# Access Compliance Report

## Public Rights-of-Way

### (Curb Ramps)

Intersection ID: 18178	Main Street: HODGSON_RD	Cross Street: RANDOLPH_RD	Location: NW
ADA ID: 94C061135034	Ramp Type: PerpDiag	Initial Pass/Fail: Fail	Overall Compliance: No
Severity Score: 21.25			
Codes/Mitigation Info/Possible Solution		Field Measurements/Component Compliance

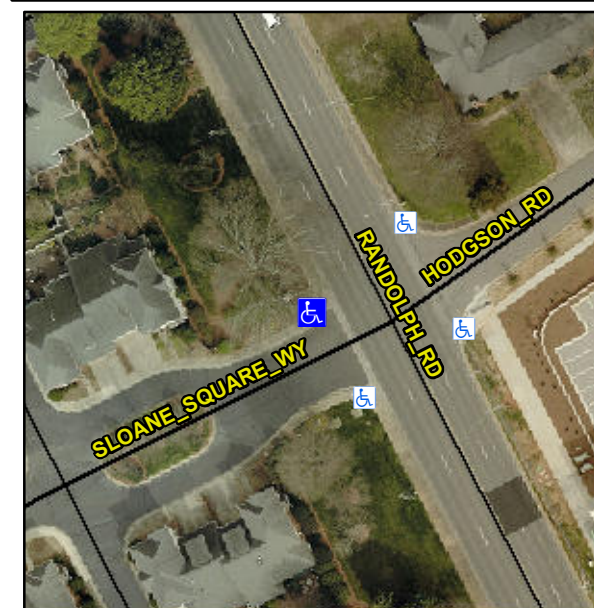
**R304.5.1, R304.2.2**

Compliance	Description	Data	Compliance	Description	Data
N/A	Ramp Length (in)	28.0	No	Ramp Slope (%)	9.9
No	Ramp Width (in)	45.0	Yes	Ramp XSlope (%)	0.6
N/A	Flare Type LT	N/A	N/A	Flare Type RT	N/A
N/A	Flare Slope LT (%)	N/A	N/A	Flare Slope RT (%)	N/A
N/A	Flare Traversable LT?	N/A	N/A	Flare Traversable RT?	N/A
N/A	Landing Length (in)	N/A	N/A	DWS Provided?	N/A
N/A	Landing Width (in)	N/A	N/A	DWS Contrast?	N/A
N/A	Landing Slope (%)	N/A	N/A	DWS Length (in)	N/A
N/A	Landing X Slope (%)	N/A	N/A	DWS Full Width?	N/A
N/A	Landing Curb? (Y/N)	N/A	N/A	DWS Offset (in)	N/A
N/A	Shared Landing?	N/A			
N/A	Gutter Ponding?	N/A	N/A	Gutter Slope (%)	N/A
N/A	Gutter Lip Ht (in)	N/A	N/A	Gutter X Slope (%)	N/A
N/A	Painted X Walk1?	No	N/A	Painted X Walk2?	No
	X Walk 1 Direction	To SE		X Walk 2 Direction	To NE
N/A	X Walk 1 Width (in)	N/A	N/A	X Walk 2 Width (in)	N/A
	X Walk 1 Slope (%)	2.7		X Walk 2 Slope (%)	3.7
	X Walk 1 X Slope (%)	4.1		X Walk 2 X Slope (%)	0.5

**Remove & Replace Curb Ramp With Two New Directional Ramps or Equivalent.**
